# Shift Lever Slide Cover Deformation

**Section** Automatic Transmission/Transaxle

YEAR(S)	MODEL(S)	ADDITIONAL INFORMATION
2013 – 2015	RAV4

**Figure 1.**

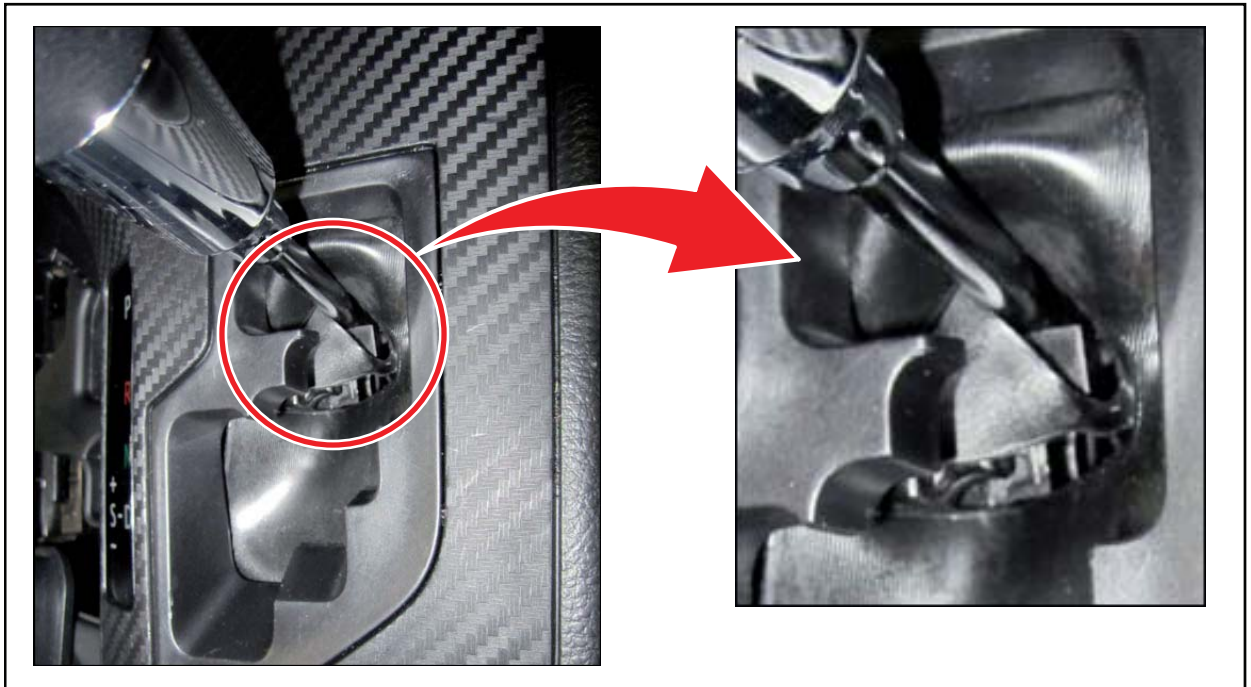
- Damaged Slide Cover due to deformation or distortion.
- Difficult to move shifter due to interference (binding) of the Slide Cover (as shown in Figure 1).

Figure 2.

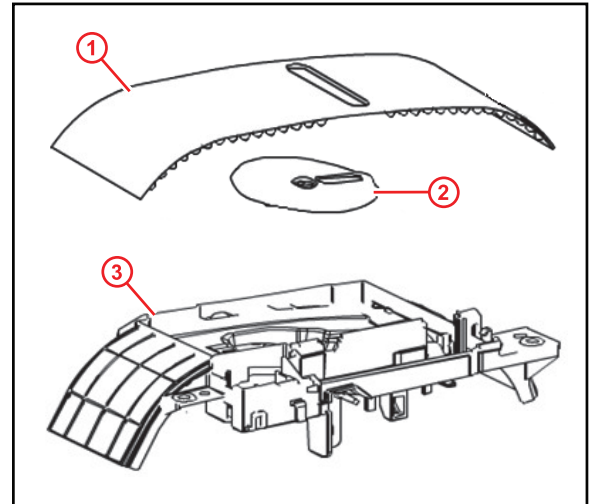
2. Remove and replace the Slide Cover, Slide Cover No. 2, and Position Indicator Housing.

1	Slide Cover (P/N 35975-0R030)
2	Slide Cover No. 2 (P/N 35976-0R030)
3	Position Indicator Housing (P/N 35971-0R010)

Figure 3. Position Indicator Lens

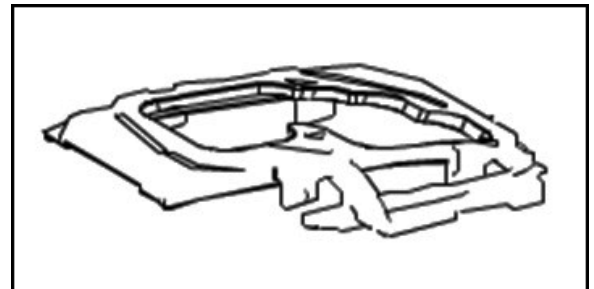
If the Slide Cover housing area has a significant amount of a sticky substance (e.g., soda or juice) after cleaning, it may be necessary to replace the Position Indicator Lens (P/N 35952-0R010, shown in Figure 3) in addition to the parts listed in the Parts Information section.
